Exploring the feasible net-zero transition pathway in China considering energy system flexibility

Corresponding Author: Professor Wenying Chen

This file contains all reviewer reports in order by version, followed by all author rebuttals in order by version.

Fig. 1 China's energy system decarbonization pathway

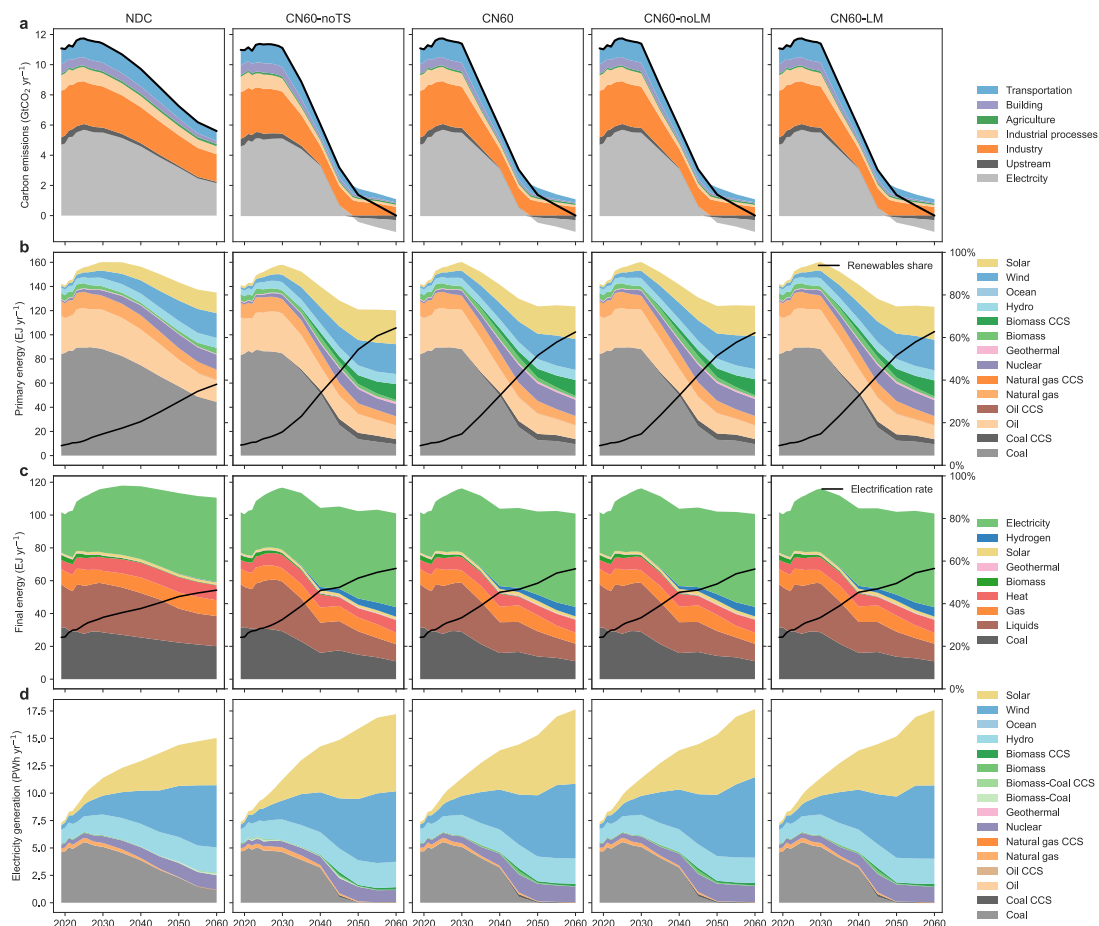
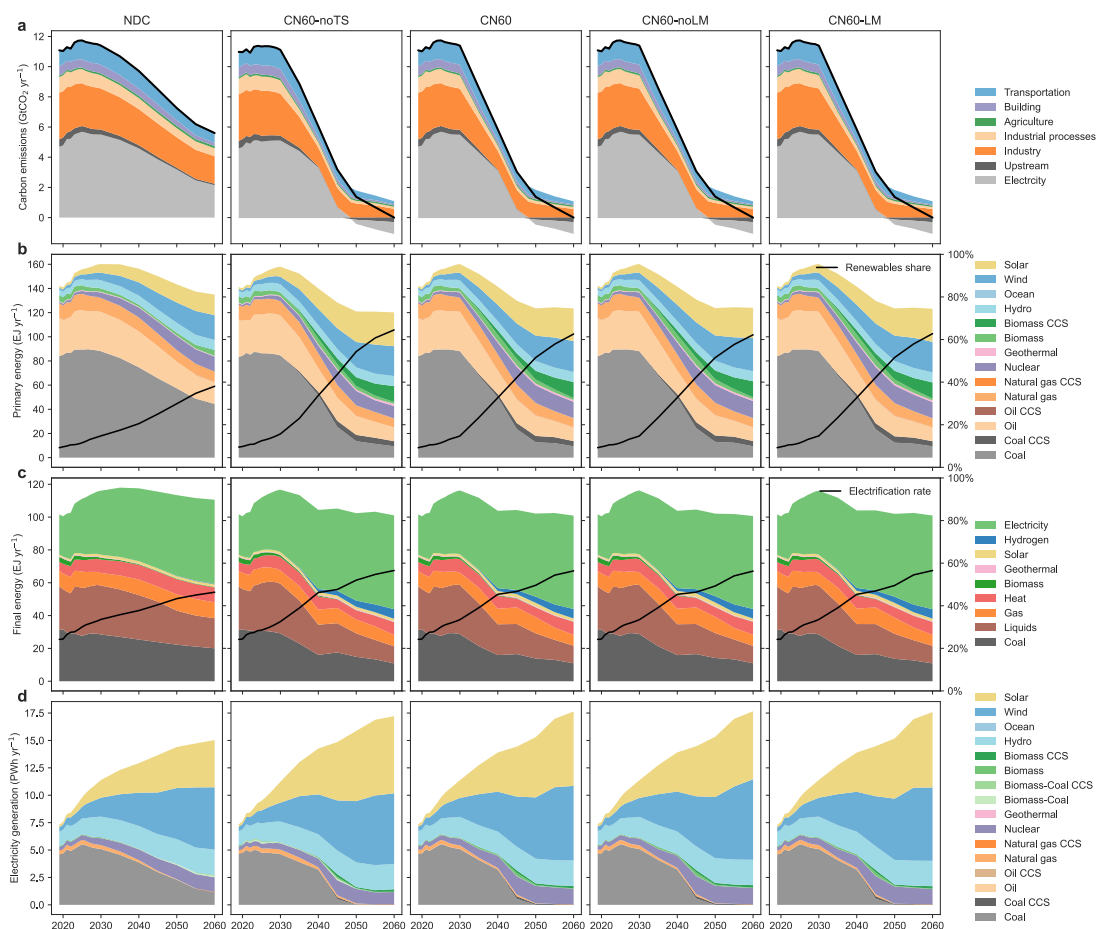
Figure 1 would benefit from including the 'noTS' scenario for completeness - although perhaps may not show key differences due to the results being presented at an annual level.

Figure 1 would benefit from including the 'noTS' scenario for completeness - although perhaps may not show key differences due to the results being presented at an annual level.

In order to further demonstrate the novelty of our paper, we have revised the results section, while we have redrawn Fig. 1 and Supplementary Fig. 13 with the addition of the CN60-noTS scenario, which illustrates the impacts of sub-annual modeling from the perspective of energy and financial flows, respectively.

(Manuscript, Fig.1) add CN60-noTS scenario

Thank you very much for your suggestion, we have added the CN60-noTS scenario in Figure 1.

(Manuscript, Figure 1) modify figure.

Supplementary Table 5 Power plant construction, energy storage construction, hydrogen electrolyzer construction and demand side response costs.

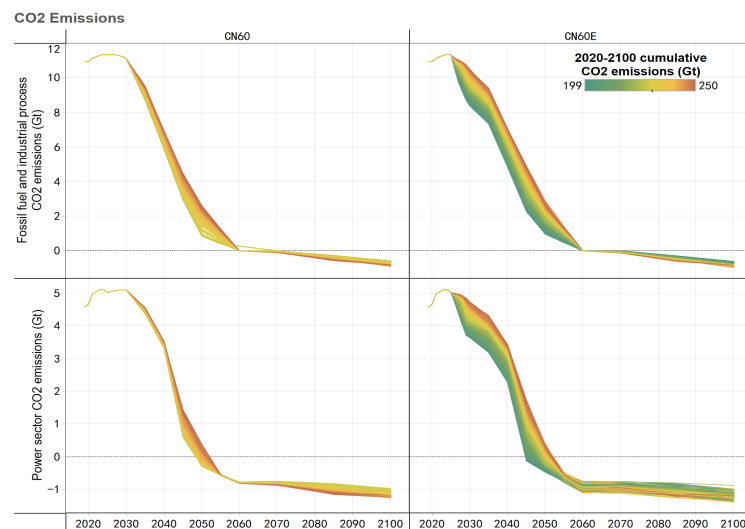
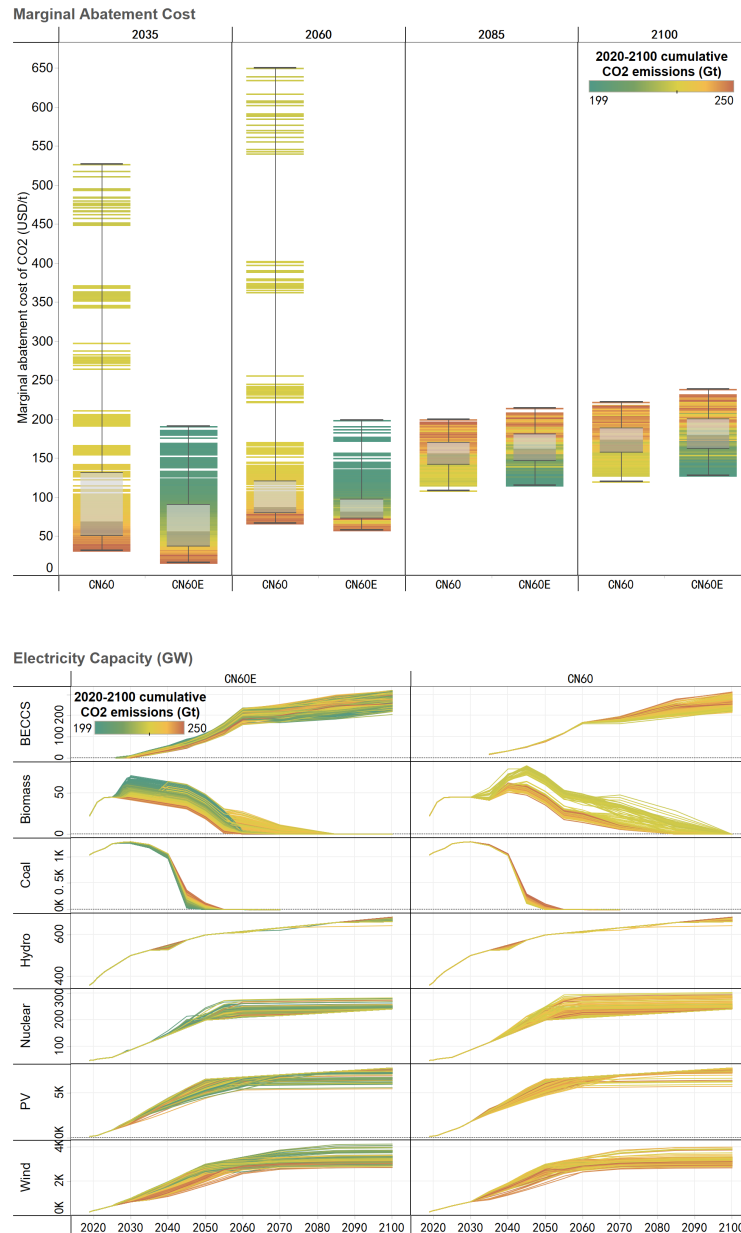
- 4) Parameter sensitivity analysis. The model relies on numerous predefined parameters. To assess robustness, the authors should: (a) Identify key parameters that distinguish this model from others (e.g., demand response elasticity, storage cost assumptions). (b) Conduct sensitivity analyses (e.g., Monte Carlo simulations) to quantify how uncertainties in these parameters affect outcomes (e.g., marginal abatement costs, technology portfolios).

Parameter sensitivity analysis. The model relies on numerous predefined parameters. To assess robustness, the authors should: (a) Identify key parameters that distinguish this model from others (e.g., demand response elasticity, storage cost assumptions). (b) Conduct sensitivity analyses (e.g., Monte Carlo simulations) to quantify how uncertainties in these parameters affect outcomes (e.g., marginal abatement costs, technology portfolios).

Thank you very much for your question. Modeling requires a lot of assumptions about future techno-economic parameters. For this reason, we show important cost assumptions in Supplementary Table 5.

We know that sensitivity analysis is very important. However, given the computational scale of the model (10 hours for a single scenario on a 64-core CPU workstation), large-scale sensitivity analysis is difficult at this stage, and we have a dedicated paper for parameter uncertainty (<https://www.nature.com/articles/s41467-021-27671-0>). Therefore, we performed 1000 rounds of Monte Carlo simulations using the same constraints but without the refined time resolution scenario (i.e., CN60-noTS). We set the uncertainty range for wind power costs, PV costs, nuclear power costs, BECCS costs, energy storage costs, and hydrogen energy costs to be 70%-143% of the intermediate scenario (Log-Normal distribution), and the uncertainty range for wind power installation growth, PV installation growth, nuclear power installation growth, and price elasticity to be 70%-130% of the intermediate scenario (Normal distribution). The cumulative carbon budget for 2020-2100 is 200-250 Gt (uniform distribution). In addition, we set up the On-Time Action Scenario (CN60) and the 2025 Early Action Scenario (CN60E) to represent different policy strengths. The following three figures illustrate the net-zero transition emission trajectories, marginal abatement costs, and power capacity under uncertainty perturbations in the input parameters.

(Supplementary Information, Supplementary Table 5) Add table.

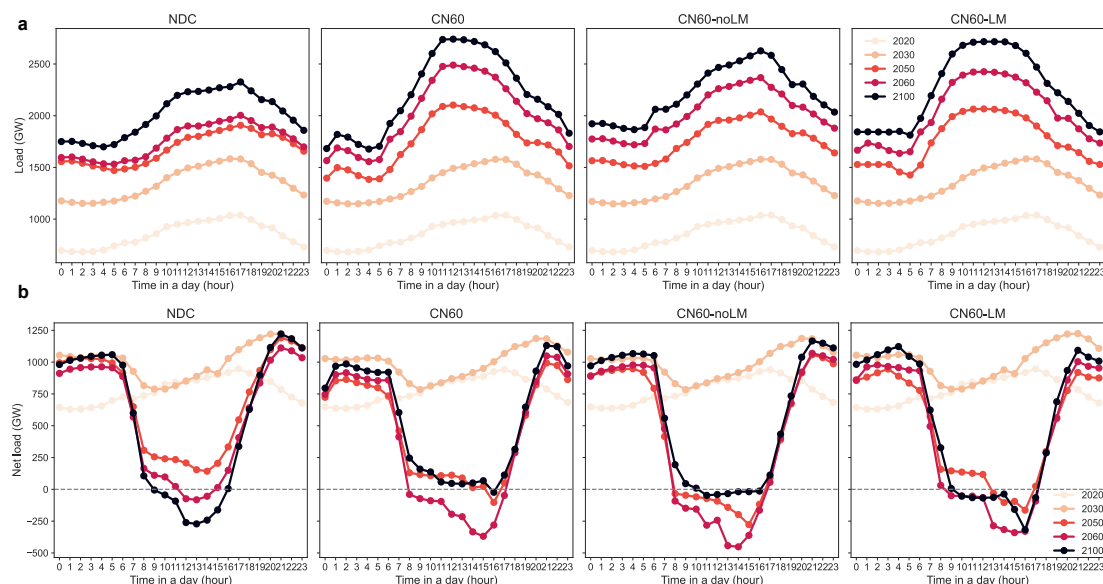
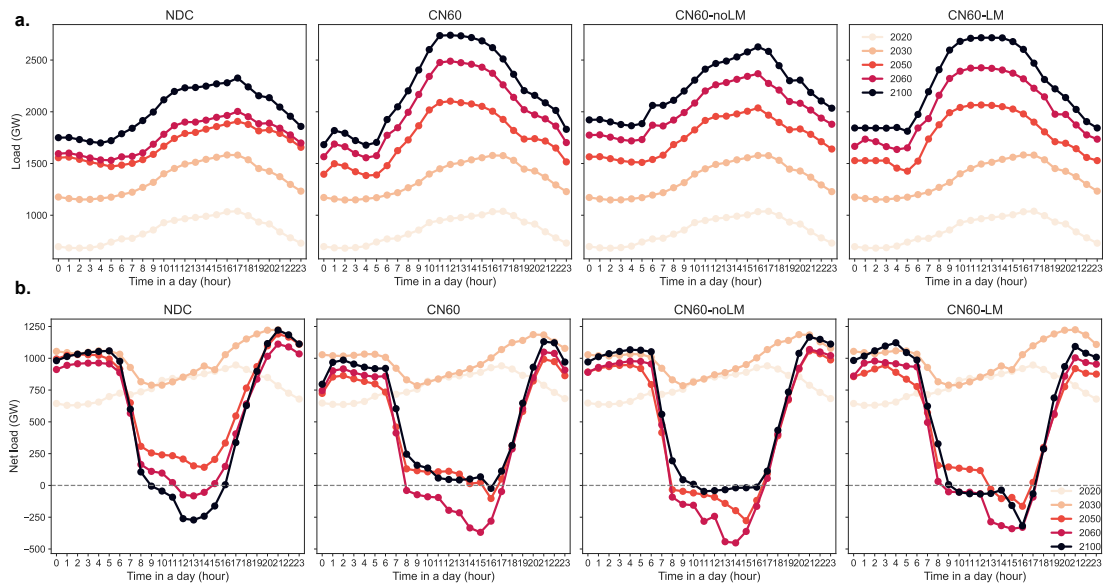
Line 174-175. You state that “Concurrently, the load profile undergoes a transformation from a relatively flat distribution to one characterized by daytime peaks, thereby aligning more effectively with the PV power generation”. Which load profile do you mean? Could you refer to the corresponding figure here?

SI Figure 6 lacks legend

Line 174-175. You state that “Concurrently, the load profile undergoes a transformation from a relatively flat distribution to one characterized by daytime peaks, thereby aligning more effectively with the PV power generation”. Which load profile do you mean? Could you refer to the corresponding figure here?

SI Figure 6 lacks legend

Thank you very much for bringing up the confusing points. What we are trying to convey here is that future loads, guided by prices, will be more concentrated when renewables are generating large amounts of electricity, and that the comparison is to the electricity load curve for the year 2020, which was not specifically plotted in the original manuscript. We present the load profiles for key years and scenarios in Supplementary Figure 6.

(Manuscript, Line 210-213) Comparing the 2060 and 2020 load profiles (Supplementary Figure 6a), the load profile undergoes a transformation from a relatively flat distribution (reducing thermal power regulation operations) to one characterized by daytime peaks (better matching PV generation).

(Supplementary Information, Supplementary Figure 6) Add Supplementary Fig. 6a.

(Supplementary Information, Supplementary Figure 6) Add legend.

Supplementary Fig. 19 V2G operations in 2060 under different scenarios

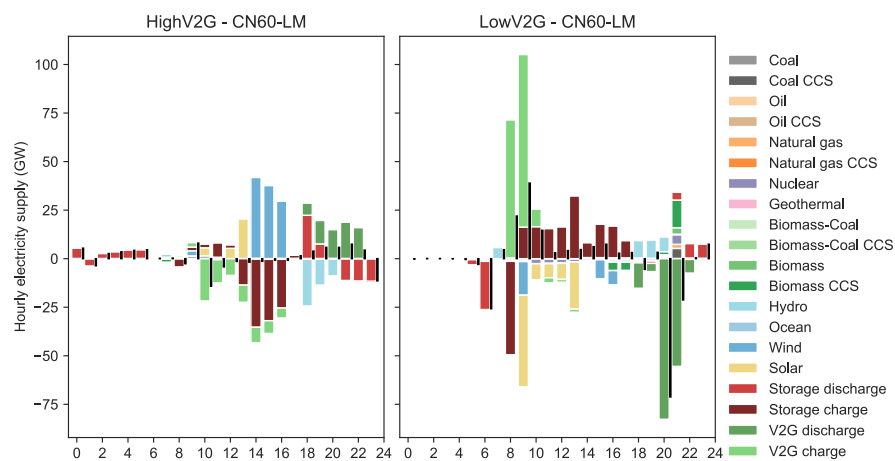
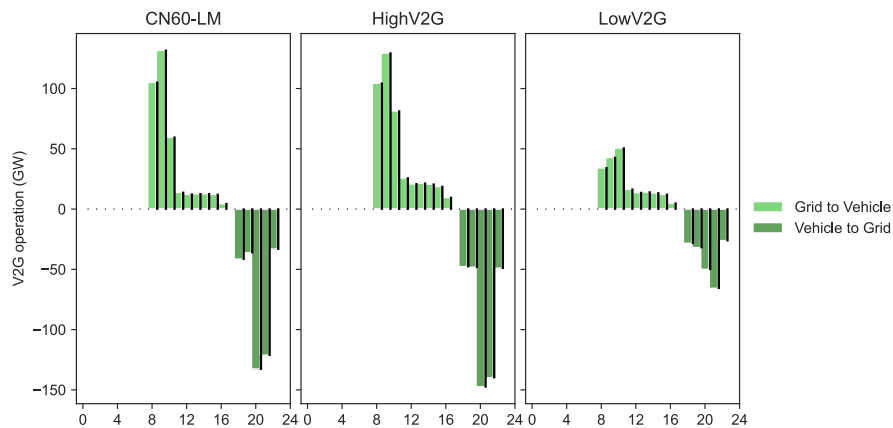
1. Sensitivity analysis should be conducted considering different V2G participation rates in the assumptions of demand-side response?
2. The sensitivity analyses should also consider different assumed costs for the flexibility retrofits of coal-fired power plants?

(Manuscript, Line 224-226) [The result of sensitivity analysis of different V2G application rates can be found in Supplementary Notes 3 and Supplementary Figures 18-19.](#)

(Supplementary Note 3 and Supplementary Figure 18-19)

[Supplementary Note 3 Sensitivity scenario analysis for V2G application rates](#)

[Demand response, such as V2G, can alleviate peak loads and reduce energy storage requirements. Based on the CN60-LM scenario, we ran two additional sensitivity scenarios and made differentiated adjustments to the participation level of V2G. Specifically, we changed the proportion of the maximum activity level of V2G in each timeslice to the electricity consumption of the transportation sector in different scenarios. For the CN60-LM scenario, in 2030, 2050, and 2110, the maximum activity level for charging or discharging in each timeslice are 20%, 30%, and 50% of](#)

From the power supply on a typical day, a higher V2G application rate (HighV2G scenario) can promote the consumption of wind power and solar power at noon (approximately 50GW), while reducing the charging and discharging of energy storage. V2G facilities primarily charge during midday and discharge in the evening. Conversely, the LowV2G scenario significantly weakens the role of V2G, resulting in a noticeable flexibility shortage around 9 PM, necessitating increased output from various power plants such as nuclear, coal-fired, and biomass to provide flexibility.

Focusing on V2G operations, it can be observed that the primary charging period for V2G vehicles is between 8 and 10 am, while the discharge period is between 8 and 9 pm. By increasing the utilization rate of V2G applications, charging during the 9 am to 2 pm period can be significantly enhanced, while discharge during the 6 pm to 11 pm period also sees an overall improvement. Through sensitivity analysis, it can be summarized that the most economical role of V2G is to provide power support during peak load and ramping periods. Under conditions of higher V2G application rates, it can partially replace the functions of energy storage facilities.

(Figure 2) add CN60-noHour and CN60-DN scenarios.

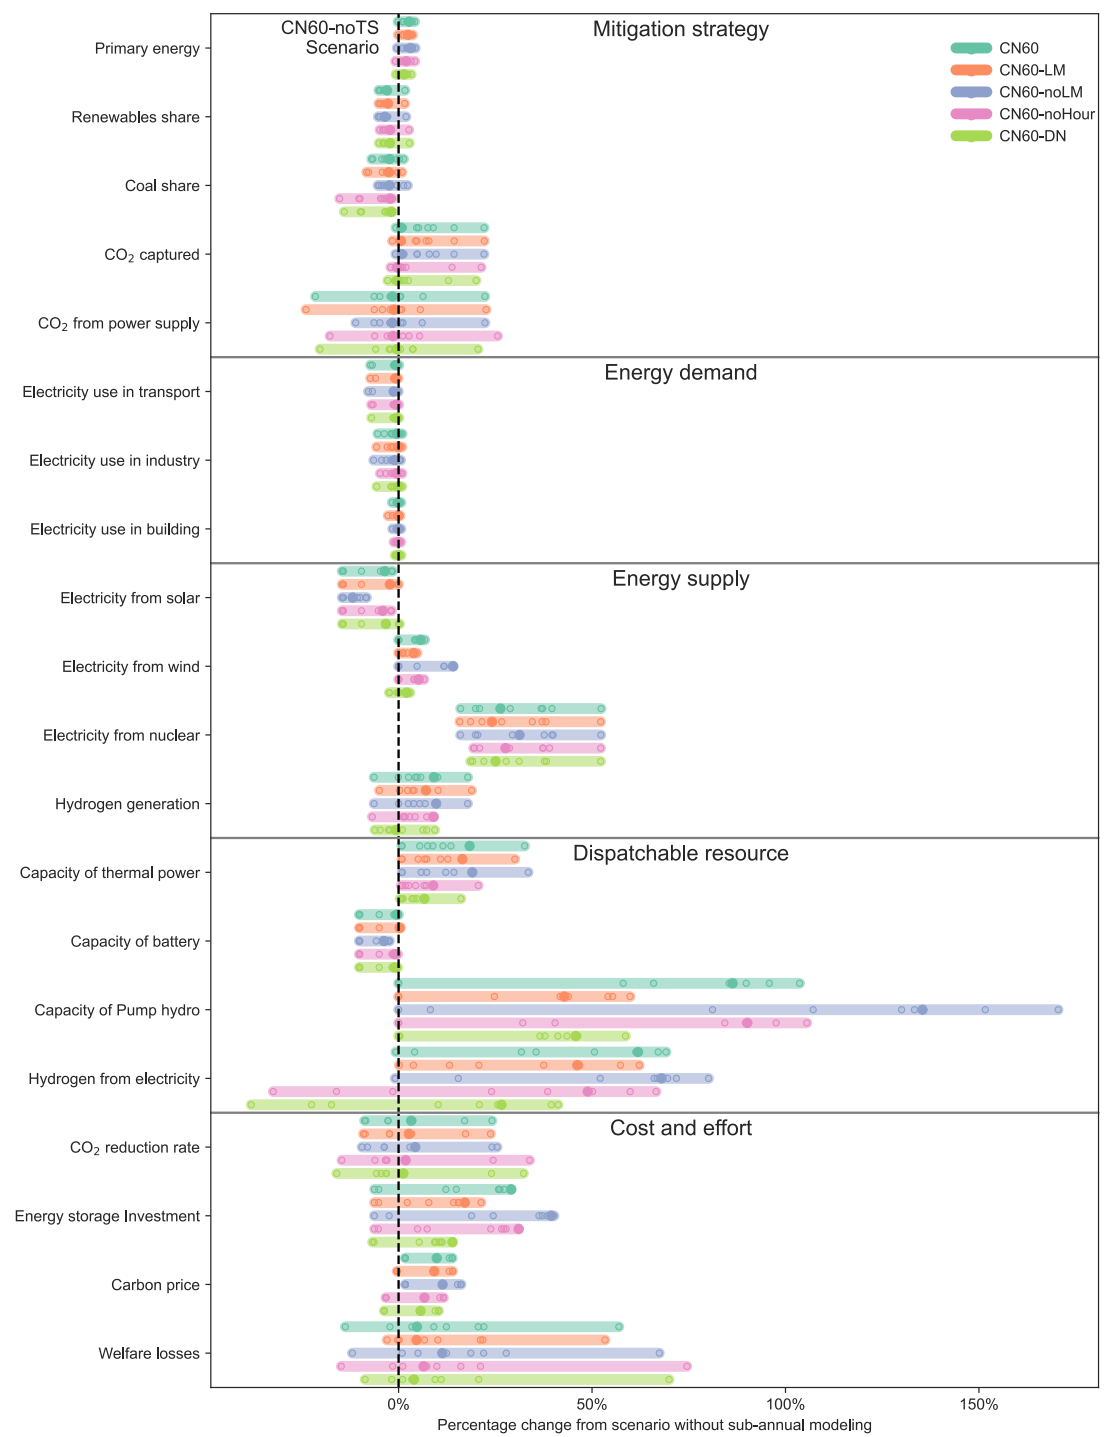
As shown in Figure 2, there is a significant difference between sub-annual and annual modelling analyses across the aspects you mentioned. However, this impact remains generally consistent across the three CN60 scenarios (e.g., sectoral electricity demand). As I understand, these variations cannot be attributed to the effects of more granular and flexible demand-side management on the net-zero transition. Instead, they likely reflect structural uncertainties in this TIMES modelling results. Therefore, I am not convinced that this sub-annual analysis demonstrates any substantial impact on the energy transition itself. Additionally, in your comparison with other modelling analyses, I recommend clarifying the key differences in scenario assumptions between your analysis and other harmonized scenarios - particularly regarding demand-side input assumptions, which may contribute more significantly to the differences you present than the variations in time slices.

As shown in Figure 2, there is a significant difference between sub-annual and annual modelling analyses across the aspects you mentioned. However, this impact remains generally consistent across the three CN60 scenarios (e.g., sectoral electricity demand). As I understand, these variations cannot be attributed to the effects of more granular and flexible demand-side management on the net-zero transition. Instead,

granularities, we added the CN60-DN scenario, which considers two timeslices for day and night, and the 32-timeslice scenario CN60-noHour, which considers 4 seasons × 2 weeks × 4 daily timeslices. For modifications to the scenario setting description, please refer to the reply to the next comment (Comment 3.4). We modified Figure 2 by adding the CN60-noHour and CN60-DN scenarios. The results of the section “Assessing the energy transition at the sub-annual level” have also been included in the comparison of the two scenarios mentioned above.

(Manuscript, Line 128-139) The coarse time granularity masks the impact of different flexibility measures. Under the CN60-LM scenario, which considers active demand-side flexibility, photovoltaics (PV) generation would decrease by 2% compared to the annual-scale model, while in the CN60-noLM scenario, which does not include demand-side flexibility measures, it would decrease by 12%. For scenarios considering 2-timeslice (CN60-DN) and 32-timeslice (CN60-noHour) scenarios, power generation would decrease by 3% and 4%, respectively. Demand for dispatchable resources would rise sharply with considerable differences between scenarios, with pumped hydro growing by 43-135% under hourly scenarios, and CN60-noHour and CN60-DN would grow by 90% and 46% respectively. Grid-connected hydrogen production would increase by more than 45% when seasonal

factors are taken into account, but only by 27% when only diurnal variations are considered.
